**AMENDMENTS TO THE DRAWINGS:**

### **REMARKS**

This communication is a full and timely response to the non-final Office Action dated October 26, 2005 (Paper No./Mail Date 10182005). By this communication, the specification and Figure 1 of the drawings have been amended.

*Fig. 1*

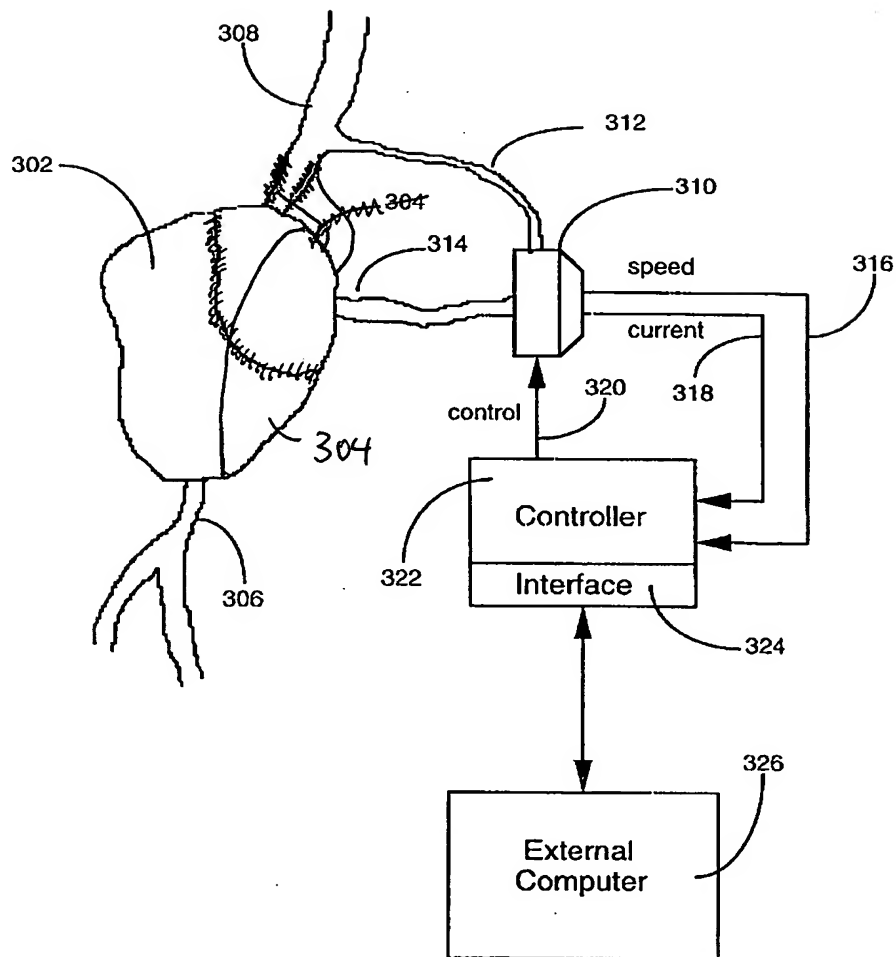
The drawings were objected to for allegedly failing to properly identify the anatomical location of the left ventricle designated by element 304 and allegedly not properly labeling the figure component designated by element 310 as a "pump". Applicant respectfully traverses these objections. However, in an effort to expedite prosecution Applicant has attached both an annotated and a replacement drawing sheet that remedy the alleged deficiencies. Accordingly, Applicant respectfully requests that the objection of Figure 1 be withdrawn.

In the replacement sheet, Figure 1 has been amended to change the location of the element number 304, as shown. Moreover, the figure component identified by element 310 has been labeled "pump", as shown.

Figure 1 has been amended to change the location of the left ventricle identified by element number 304, and to label the figure component identified by element 310 a "pump". Support for the changes to Figure 1 can be found variously throughout the specification, for example, in paragraph [0012]. No new matter has been added.
